**DOE/EA - 0993**

**ENVIRONMENTAL ASSESSMENT**

**SHUTDOWN OF THE FAST FLUX TEST FACILITY**

**HANFORD SITE, RICHLAND, WASHINGTON**

Figure 2. Core Component Container.

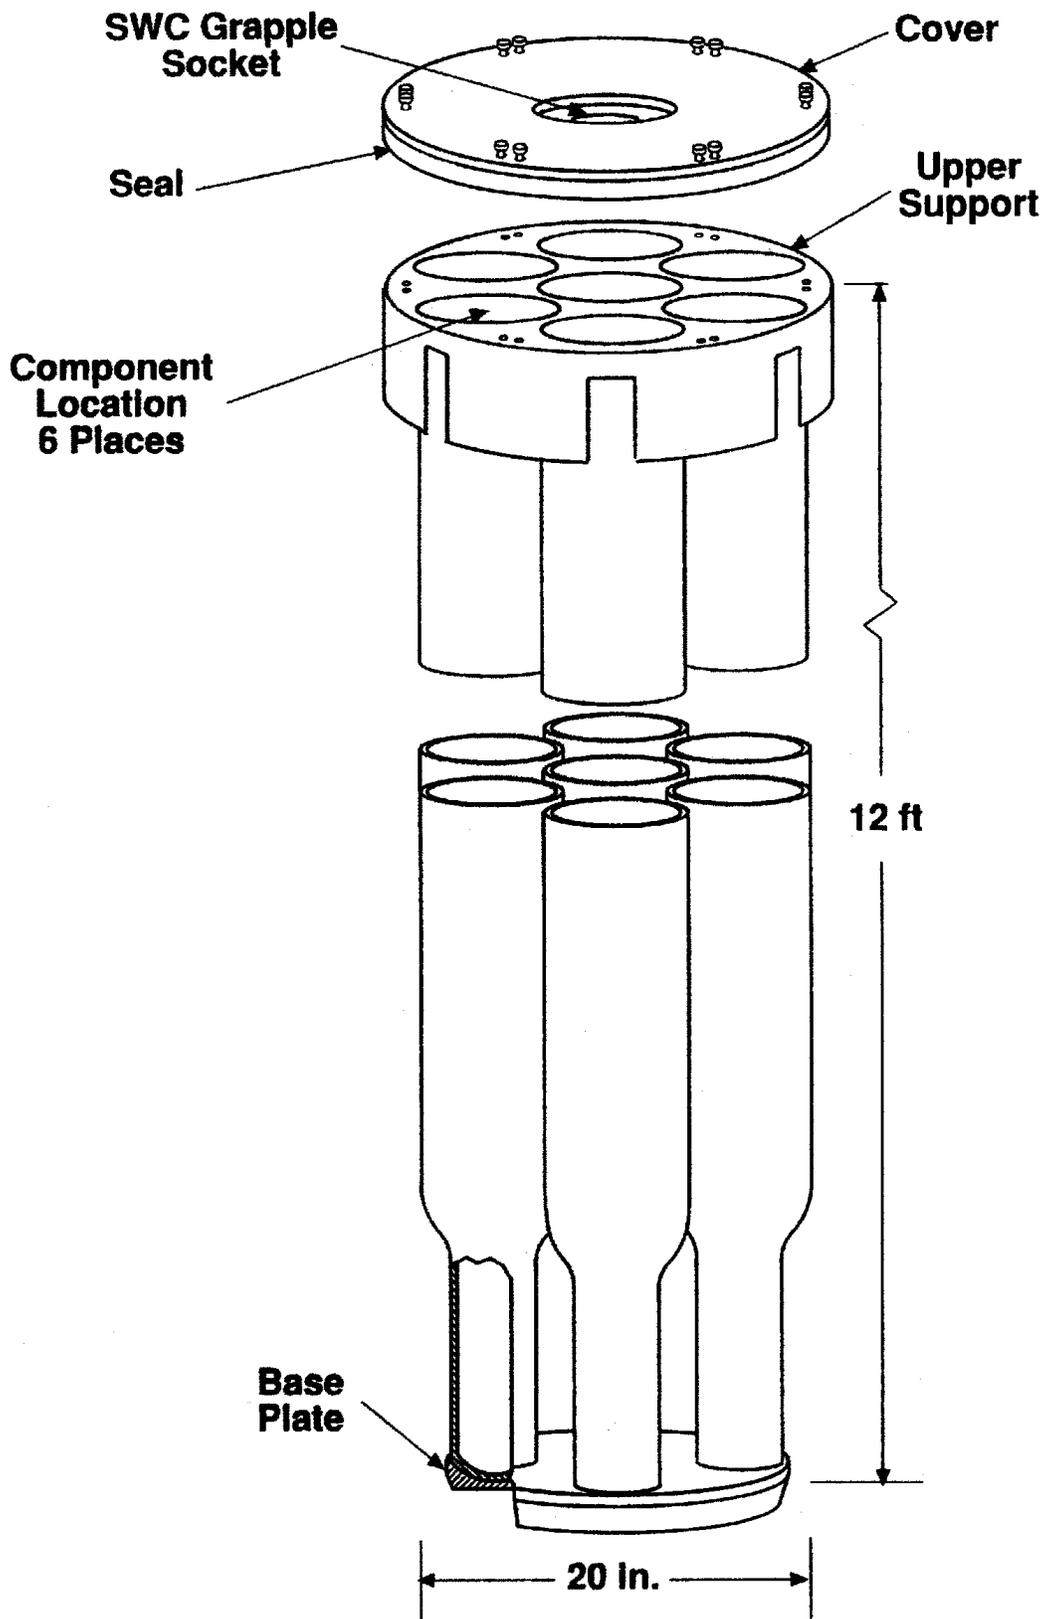
Comment: Yakama Nation recommends using a CCC with a 500-year design life to minimize the need for future repacking or handling of the materials.

Figure 3. Interim Storage Cask.

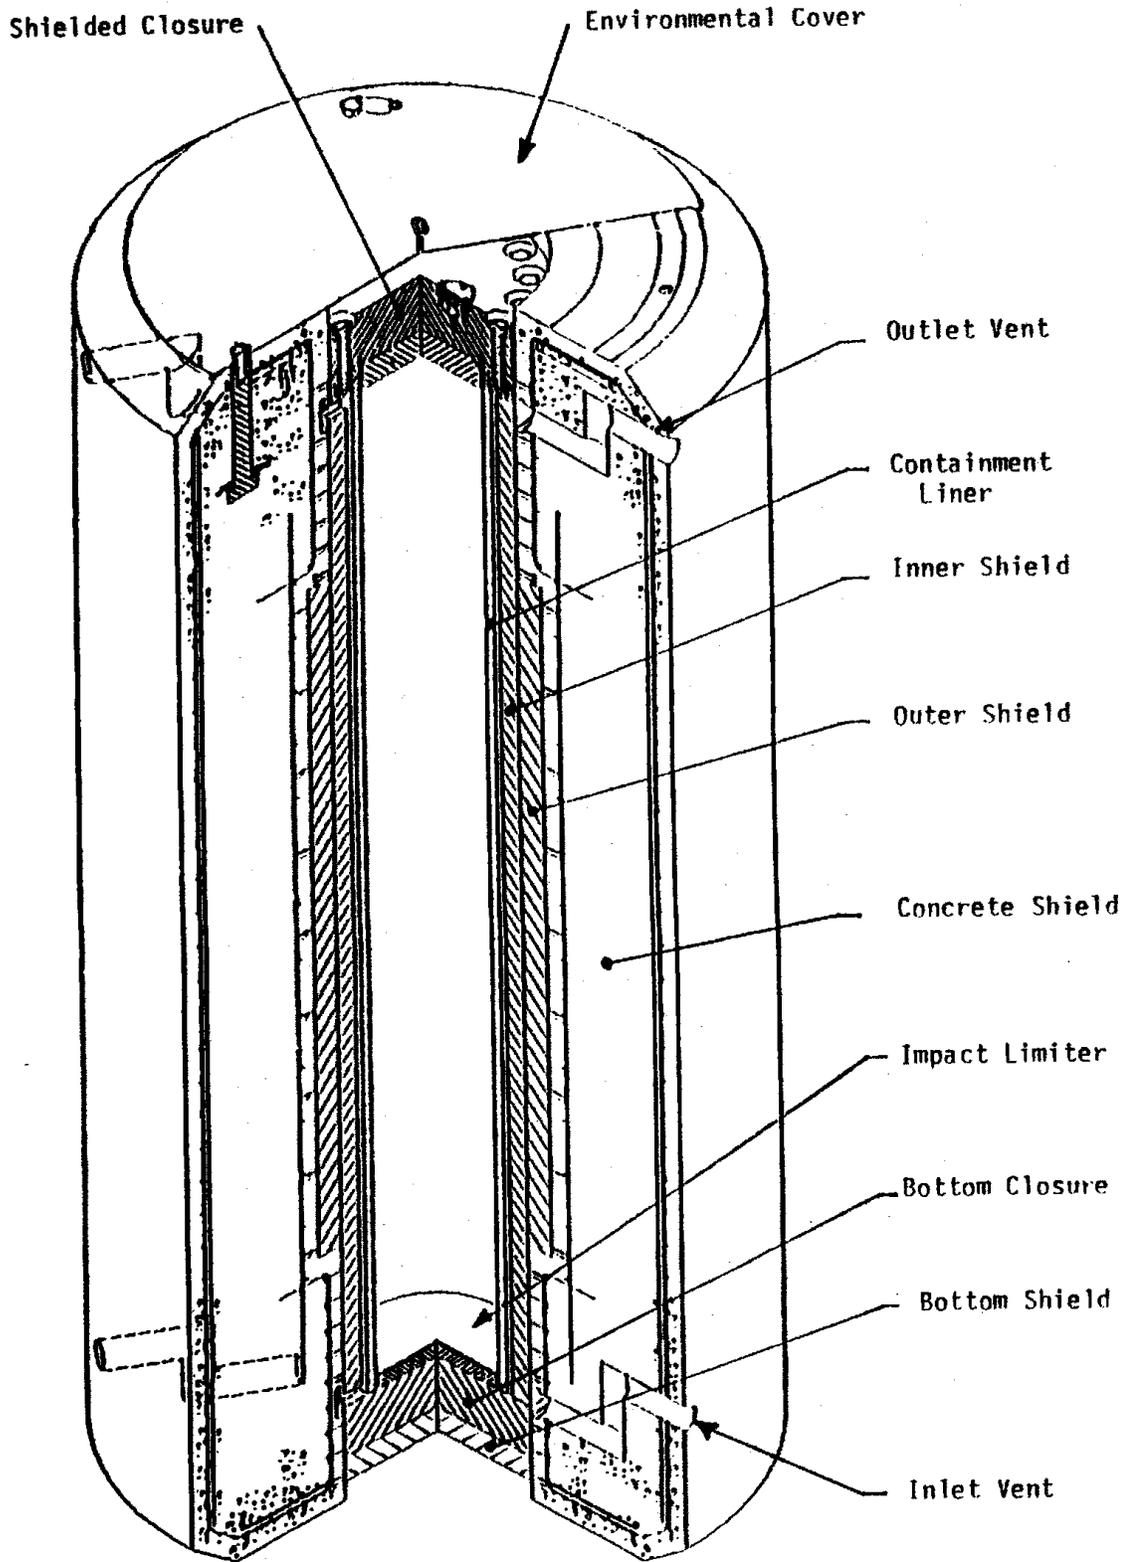
Comment: Yakama Nation recommends using a ISC with a 500-year design life to minimize the need for future repacking or handling of the materials within the cask which would be necessary if a shorter design life was specified. In addition, a multi-purpose design which allows for transportation over public highways and long term storage is recommended.

Comment: As described in an earlier comment, the ISC should be a licensed design for multi-purpose use and a 500 year design life. This will allow any casks containing sodium-bonded fuel assemblies to be transported to INEL without repacking or double-handling, if this alternative is elected in the future.

**Comment:** Yakama Nation recommends using a ISC with a 500-year design life and suitable for disposal in a deep repository to minimize the need for future repacking or handling of the materials within the cask which may be necessary if a shorter design life were specified. In addition, a multi-purpose design which allows for transportation without fuel handling is recommended. Accordingly, the Yakama Nation recommends that the ISC be designed to meet license requirements.

Section 3.1 of the EA will be revised to clarify that the ISCs have provisions incorporated into the design to accommodate future on-site transfer.
